**ITEM #2 - PRELIMINARY PLAT
HIDDEN HILLS TRACT G5 REPLAT**

KPB File No.	2023-092
Plat Committee Meeting:	September 11, 2023
Applicant / Owner:	Allen and Linda Engebretsen of Homer, Alaska
Surveyor:	Stephen Smith / Geovera, LLC
General Location:	Anchor Point / Anchor Point APC

STAFF REPORT

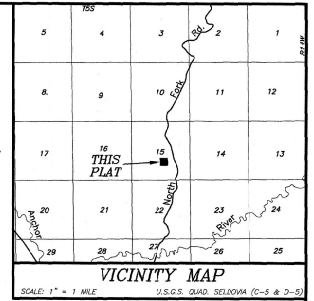
Staff recommendation: Please show less area in the vicinity map to give a closer view of where the subdivision is located.

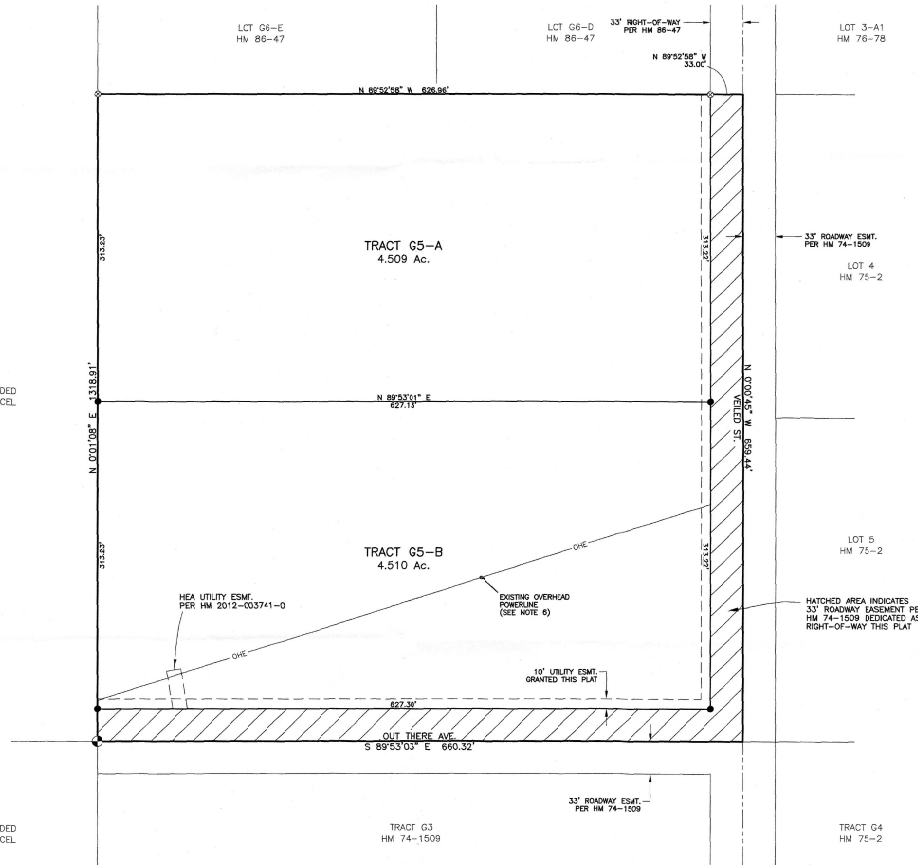
Staff recommendation: Update the KPB file number to 2023-092. Correct the aliquot description and Township and Section.

Change the acres to 9.991 to include the right-of-way area. As they were easements before.

Staff recommendation: Please correct the plat number for G4 located to the southeast. The plat 75-2 is the vacated right-of-way included in this parcel.

Include the filing information of the easement in plat note #6.

Staff recommendation: Depict the building setback along both dedications.

- West line of the plat needs correct distance listed on the primary drawing.
- North line should give an overall distance for the line on the primary drawing.

- Add Certificate of Acceptance
- Add date of September 11, 2023 to Plat Approval certification
